SAFETY EVALUATION BY THE OFFICE OF NUCLEAR REACTOR REGULATION

RELATED TO AMENDMENT NO. 5 TO

RENEWED FACILITY OPERATING LICENSE R-102

THE UNIVERSITY OF NEW MEXICO

2.12 TS 6.0, "Administrative Controls," Figure 1 (Organizational Chart)

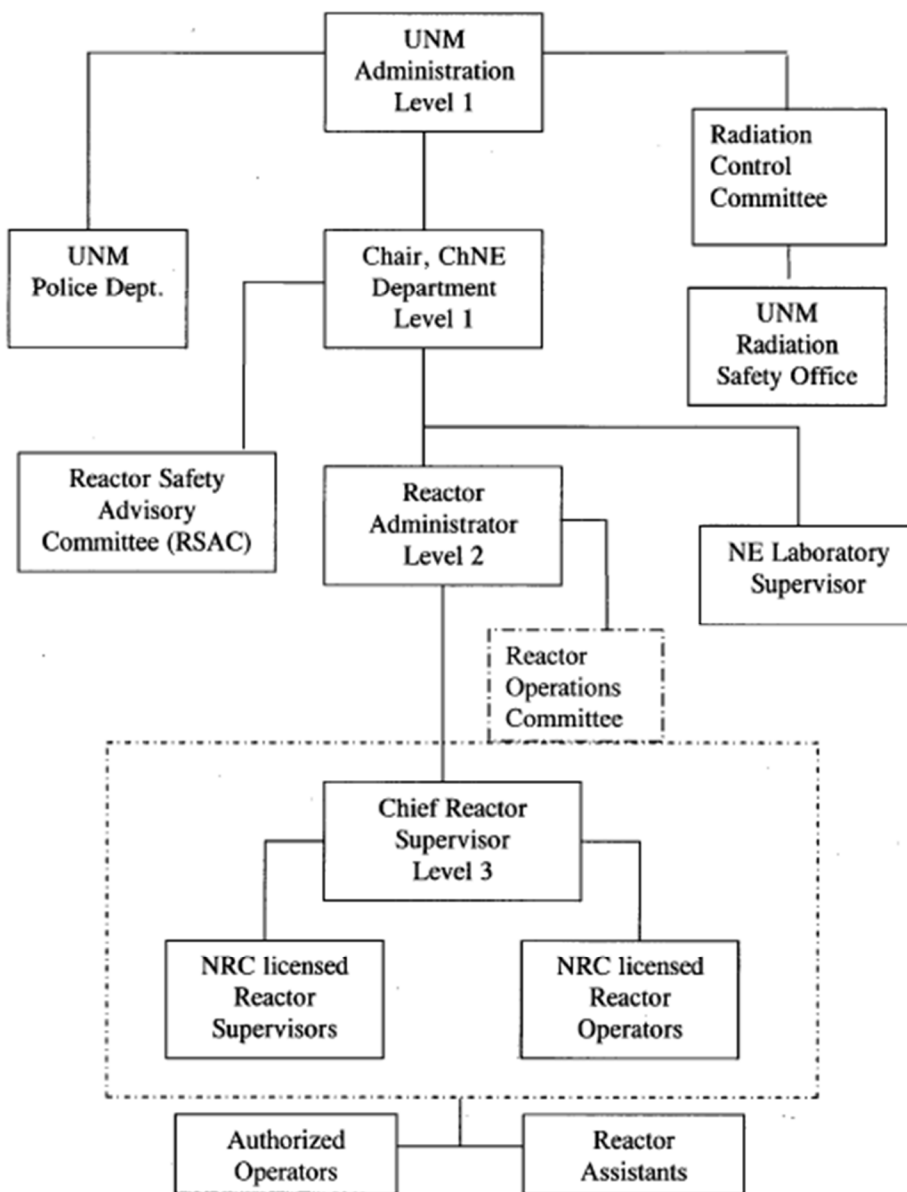
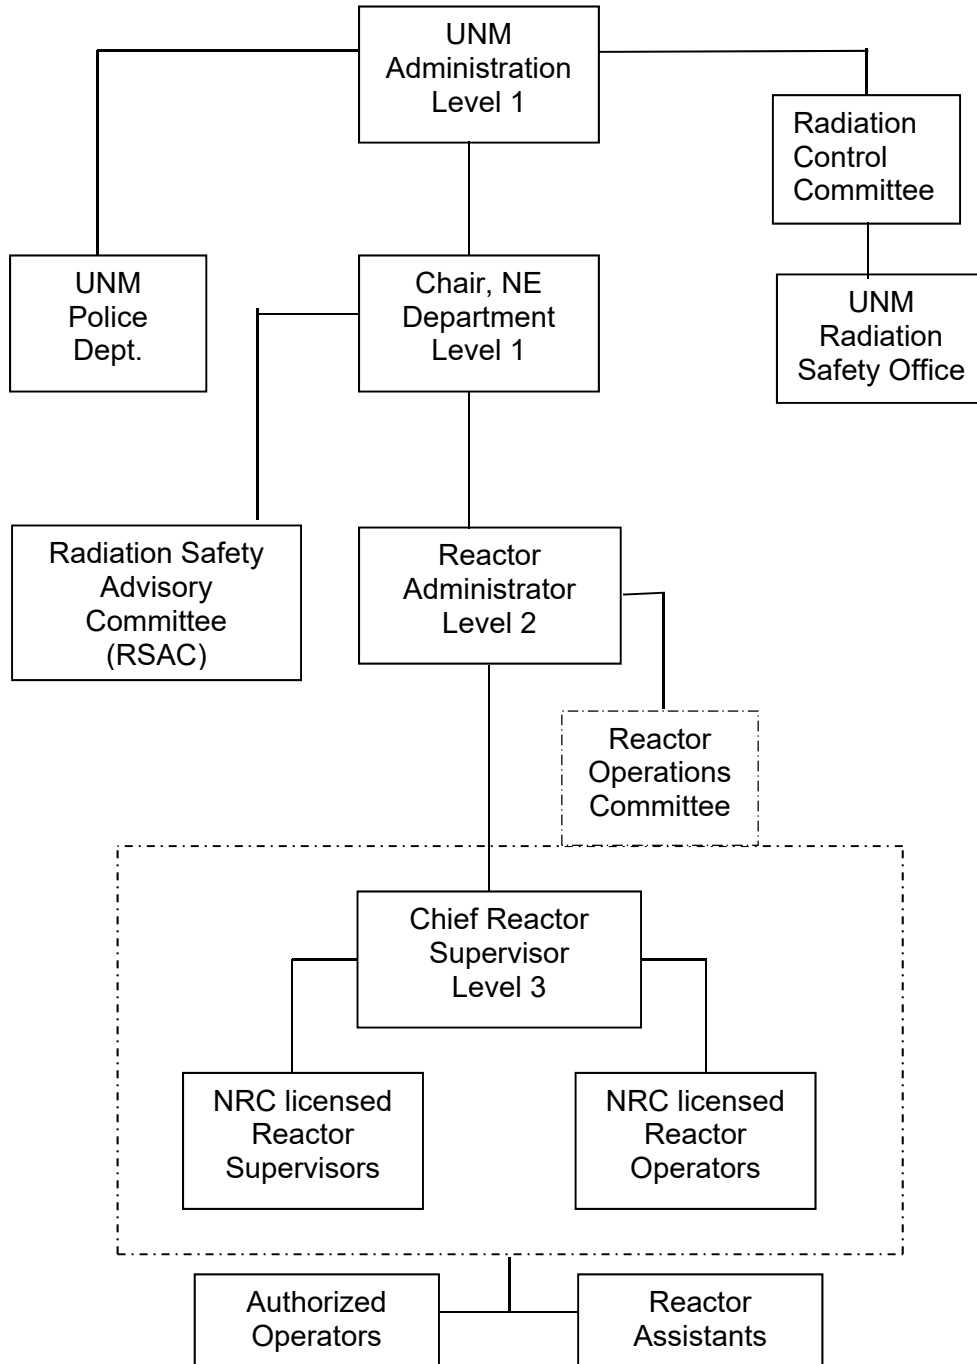
UNM proposed to revise TS 6.0, "Administrative Controls," Figure 1, to update the title of the chair of the chemical and nuclear engineering department to the chair of the nuclear engineering department due to the reorganization of the departments at UNM, and to remove the nuclear engineering laboratory supervisor from the organization chart.

UNM proposed to update the title of a Level 1 position in TS 6.0, Figure 1, by deleting “Ch” to reflect the change in the name of the department. UNM reorganized its “Department of Chemical and Nuclear Engineering” by splitting that department to create a new, stand-alone “Department of Nuclear Engineering.” UNM’s proposed changes to TS 6.0, Figure 1, would also delete the Nuclear Engineering Laboratory Supervisor from the organization chart. In its letter dated September 19, 2017, UNM stated that this position is not required because the Nuclear Engineering Laboratory Supervisor has no reactor responsibilities. The NRC staff evaluated the proposed changes using guidance in ANSI/ANS-15.1-2007, Section 6, Figure 1, and guidance in ANSI/ANS-15.4-2016. The NRC staff finds that the changes are to the position or title of an officer of the licensee, and that the Nuclear Engineering Laboratory Supervisor position is not necessary, because the Reactor Administrator and Chief Reactor Supervisor are responsible for safe operation of the reactor facility, safeguarding the public and facility personnel from undue radiation exposures, and for adhering to all requirements of the operating license and TSs. The NRC staff also finds that the proposed changes are consistent with the guidance above, and provide organization and management controls that assure operation of the facility in a safe manner as required by 10 CFR 50.36(c)(5). Therefore, the NRC staff concludes that the proposed changes are acceptable.
